Item 4.**Development Application: 256 Crown Street Darlinghurst - D/2023/265**

File No.: D/2023/265

Figure 36: Proposed location of cultural and creative space within level 1 and 3

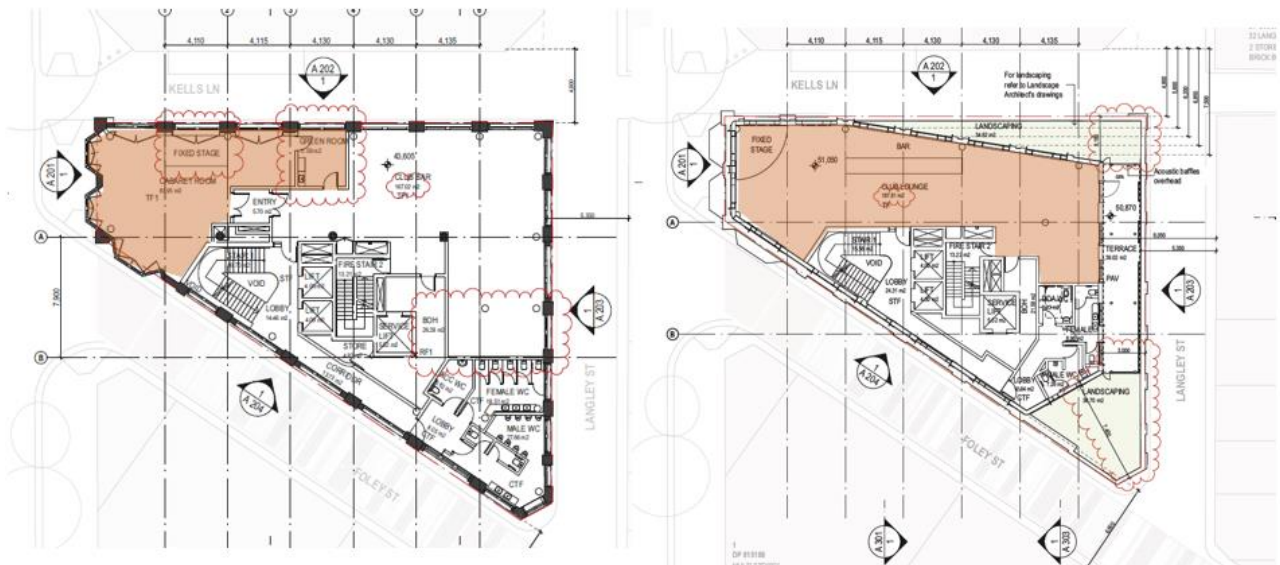
49. The existing building does not contain existing approved cultural and creative uses.
50. The proposed overall gross floor area of the building is 1,956sqm. The development proposes 10 per cent (195,6sqm) of the gross floor area of the development for cultural and creative purposes, including a cabaret room and green room on level 1 and a live performance space with fixed stage on level 3 (see Figure 36). The proposed uses comply with the definition of cultural and creative purposes being uses for live entertainment, music and performing arts.

51. A design modification condition is recommended within Attachment A for the live entertainment area to include a greenroom to ensure that the space provides appropriate facilities for performance space in accordance with Section 5.11.2 and the Creative Spaces guideline in Schedule 13 of the Sydney DCP 2012.

Figure 38: Views from the sun of the development at 12.30pm at June 21 (private open space area of 261 Palmer circled in red).

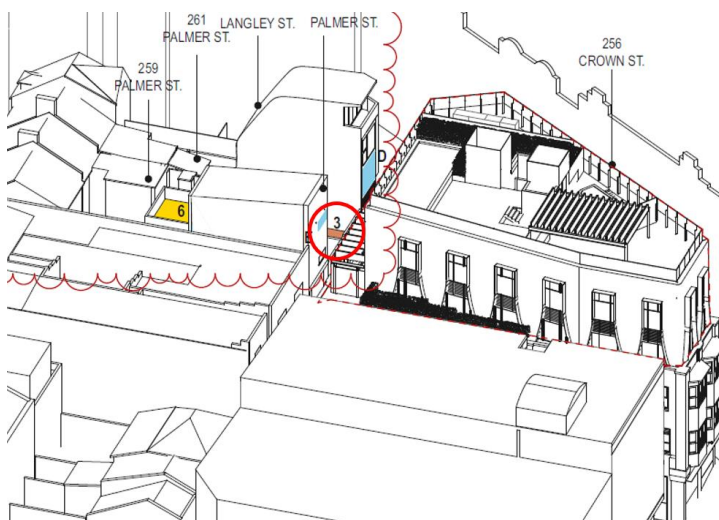
72. It is understood that the primary living area and living room window to No. 261 Palmer is located to the west of the site along Palmer Street and is not impacted by the development.
73. The private open space area of this dwelling is located on the ground level to the west of the house (facing the proposed development) (see Figure 37).
74. The submitted solar diagrams indicate that the ground level private open space area does not currently receive compliant solar access, receiving about 3sqm at 12midday, 1.7sqm at 1pm and none by 1.20pm.
75. The submitted views from the sun show that the acoustic screen and roof structure to the proposed third floor terrace of the proposed development will begin to create additional shadows to this private open space at 12.30pm (see Figure 38).

76. A design modification condition has therefore been included within the recommended conditions of consent to remove this level 3 terrace and its considerable bulk. This will lessen the overshadowing impact (and reduce privacy impacts discussed below) to the adjoining residential properties.

Figure 39: Proposed windows to be widened along the Kells Lane elevation circled in red

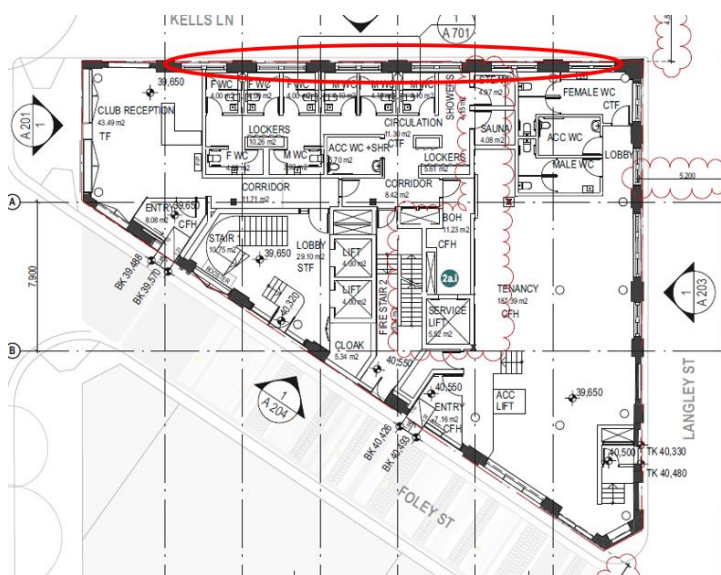
79. The proposed development generally retains the existing window locations within the contributory building. This is considered a current commercial/ residential interface, and no additional privacy treatments are required for the existing situation where windows are not being altered.
80. Some widenings of existing windows are proposed along the Foley Street, Langley Street and Kells Lane elevation. Two existing obscured glass block windows are also proposed to be replaced with new windows along the Langley Street elevation.
81. The proposed window widenings along Foley Street abut the existing commercial building at 82 - 106 Oxford Street and are considered acceptable.
82. The proposed widened windows along the ground level of the Kells Lane elevation are to proposed bathrooms within the development (see Figure 39 below).

83. A design modification condition has therefore been recommended within Attachment A to ensure these windows (gr.2, gr 3, gr 4, gr 5, gr 6 and gr 7) are obscured glass to minimise privacy impacts into and out of the development. The widening of window W2.7 on level 2 of this elevation abuts frosted glass windows and windows to a stair corridor within the adjoining residential building at No. 254 Crown Street. No further treatment of this window is considered necessary.

Figure 40: Overlooking impacts from widened windows W2.8 and W2.12 to No. 251-244 Palmer and 257 Palmer Street (yellow cone)

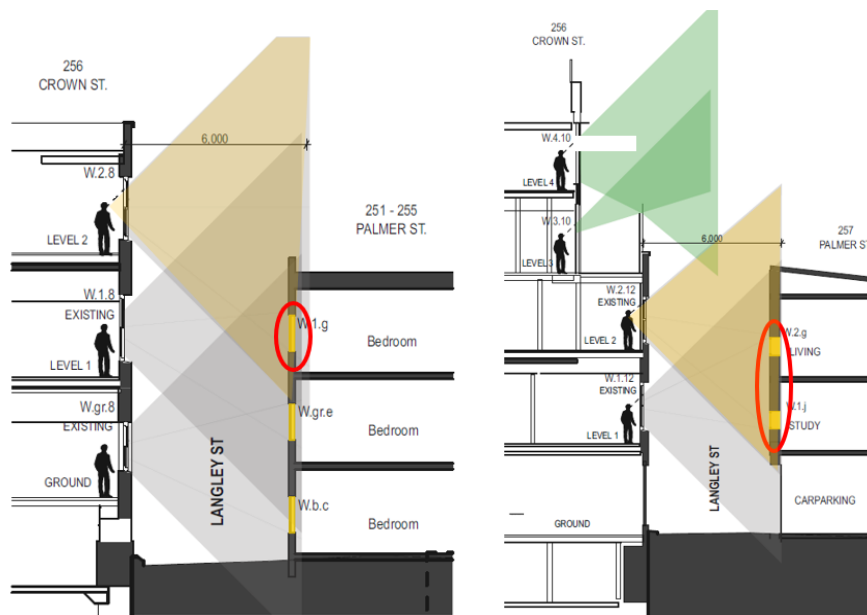
84. The proposed widening of existing windows (W1.13, W2.9 and W2.8) and the replacement of the existing obscured glass block windows (W1.12 and W2.12) at the first and second floor along the Langley Street elevation will have a privacy impact to neighbouring properties. These windows will increase overlooking impacts on the adjoining residential development at No. 257 Palmer and No. 251 - 255 Palmer (see Figure 40 below).

85. A design modification condition has therefore been recommended to ensure that windows W1.13, W2.9, W2.8, W1.12 and W2.12 incorporate obscured glazing to minimise impacts.

Figure 43: Edited extract of privacy analysis which demonstrates overlooking from the proposed Level 3 terrace (red cone) to No. 257 Palmer Street

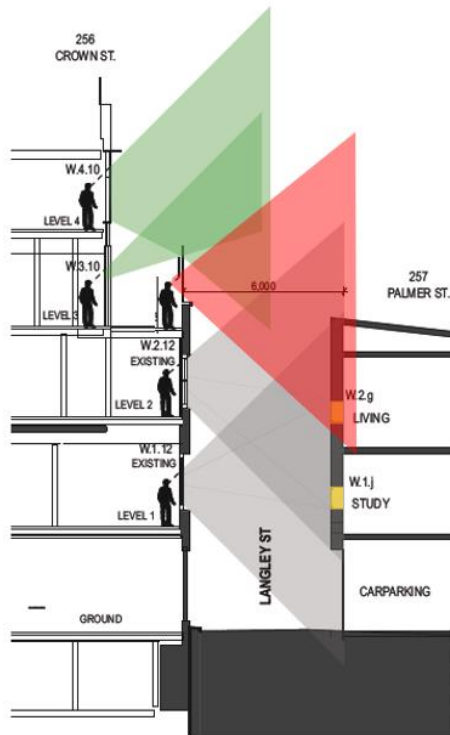
90. The Level 3 terrace proposed along the eastern boundary is shown on the plans to incorporate a 3m high clear glass noise reduction screen and overhead baffles. Without a solid privacy screen along this boundary, which would further increase the bulk of the new addition to Langley Street, the terrace will have overlooking impacts on adjoining residences at 257 Palmer and 251-255 Palmer Street (see Figure 43).

91. As discussed above under the heading 'Overshadowing', conditions have been recommended to delete the Level 3 terrace from the plans. The removal of this terrace and inclusion of planting in the 3m setback would limit overlooking from the development in accordance with the requirements of the Sydney DCP 2012. The new windows to the addition behind this terrace are not considered to have an overlooking impact due to the retention of the existing solid parapet and the 3m distance from the windows to the building edge.

Figure 44: Extract from visual privacy analysis showing likely view cone from the rooftop terrace across Kells Lane

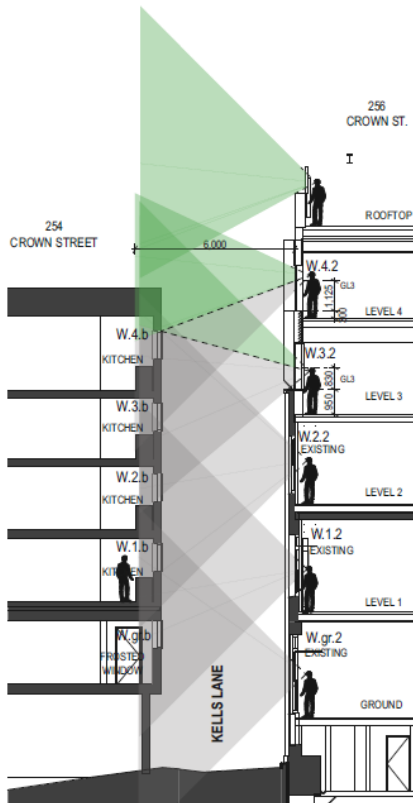
92. The submitted visual analysis demonstrates that due to the level distance of the proposed rooftop area and adjoining residential properties across Kells Lane and Langley Street, the terrace and pool deck will not have unacceptable privacy impacts (see Figure 44).

Figure 45: Proposed Langley Street elevation showing bulk of level 3 terrace and associated noise attenuation structures

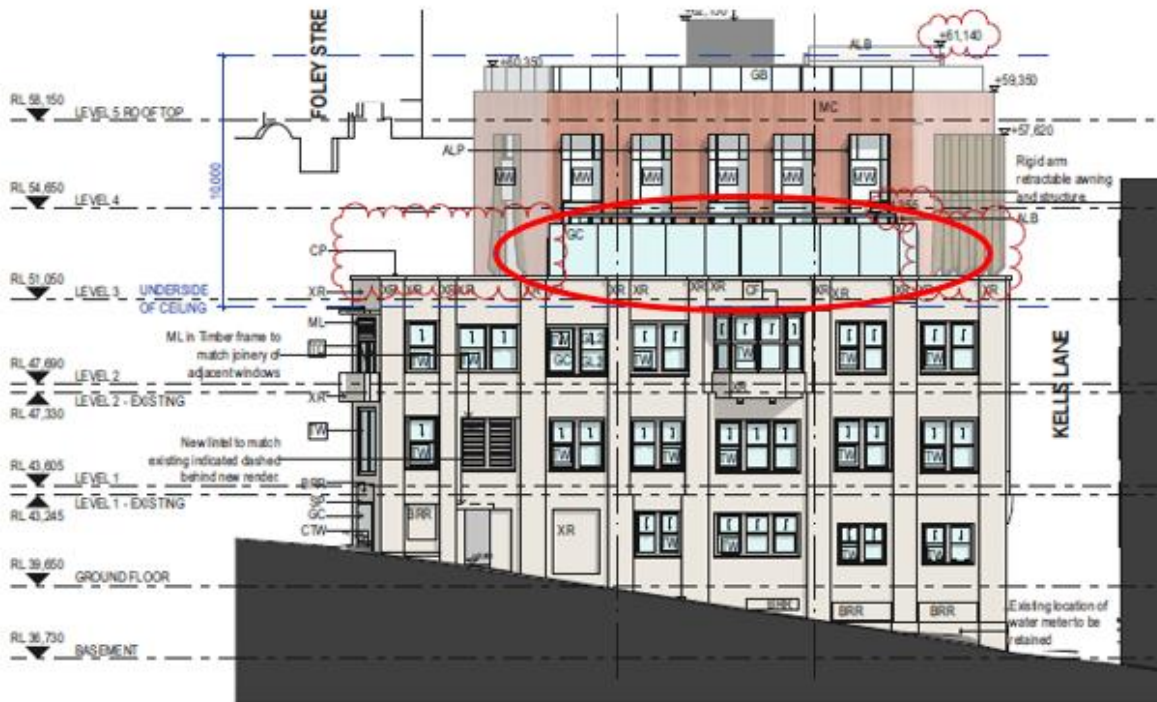
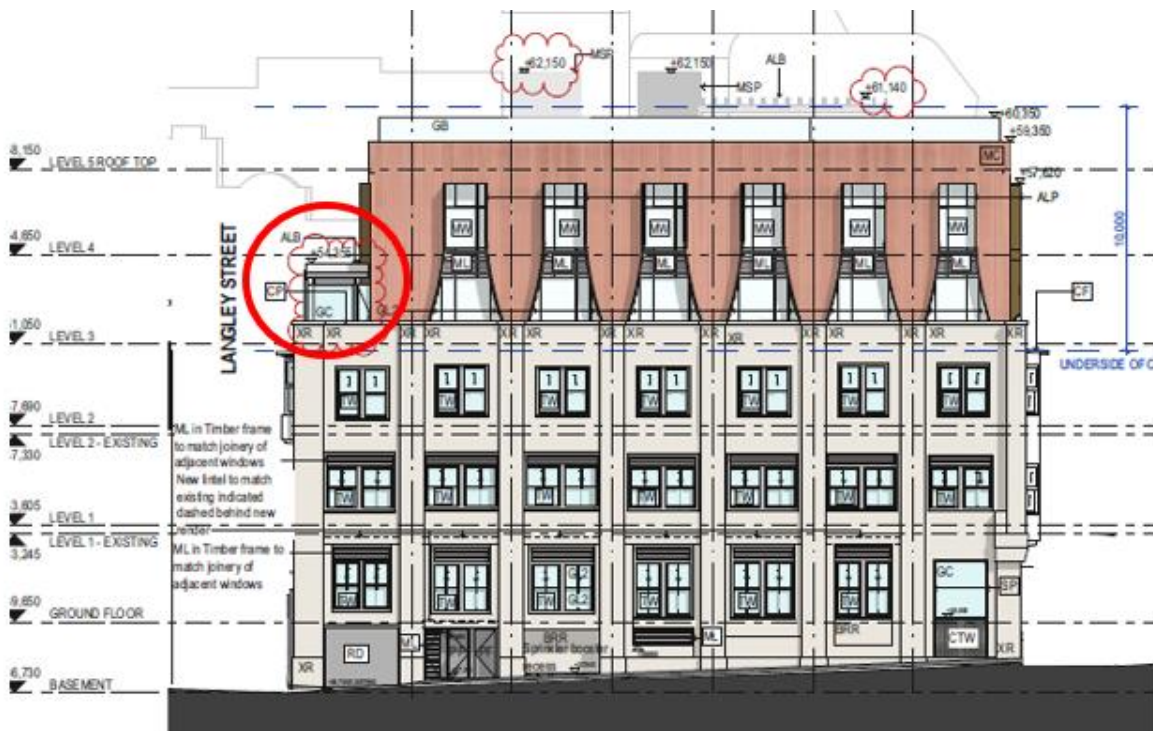
97. A 3m setback from the new addition to Langley Street is considered important in retaining a street wall height that reinforces the human scale along a street which is adjoined by 2 and 3 storey residential terraces. The proposal to incorporate the level 3 terrace, with a high acoustic barrier and overhead baffles along the boundary of this frontage is considered to add unnecessary bulk to the new additions and does not provide a true 3m setback to Langley Street (see Figures 45 and 46).

98. As discussed above, a design modification condition has been recommended to remove the proposed level 3 terrace, including the acoustic baffling and acoustic glass along the Langley Street elevation. This will assist in reducing the bulk of the upper-level addition as well as reducing overshadowing and privacy impacts in line with the controls.

Figure 48: Extract from proposed layout of the ground level tenancy (highlighted in yellow)

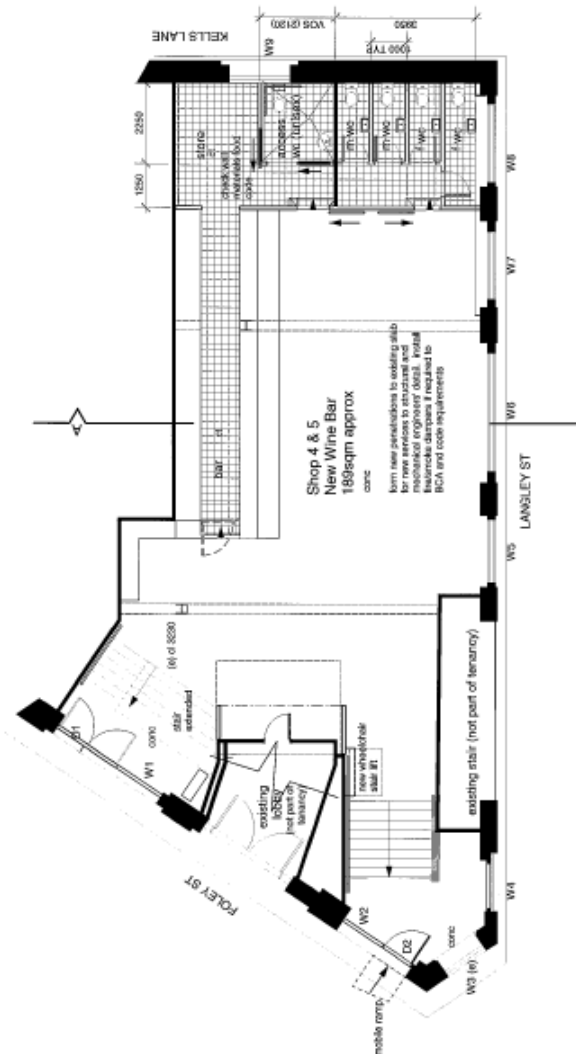
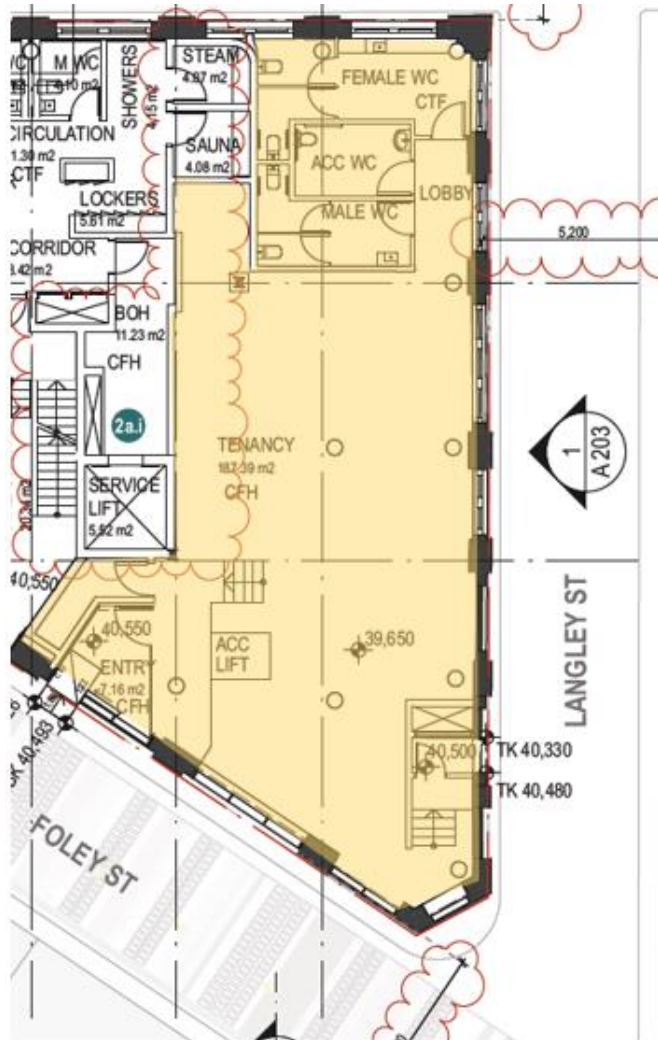
106. The subject application states that the Shady Pines tenancy will continue to occupy the ground level of the building. Whilst the proposed size and provision of sanitary facilities within the tenancy remains similar to what was approved under D/2008/1594 (as modified), some changes to the layout of the tenancy are proposed as part of the redevelopment of the site (see Figure 48).

107. A condition of consent is therefore recommended to ensure that D/2008/1594 (as amended) is amended to be consistent with the subject consent prior to issue of an Occupation Certificate for the subject premises.
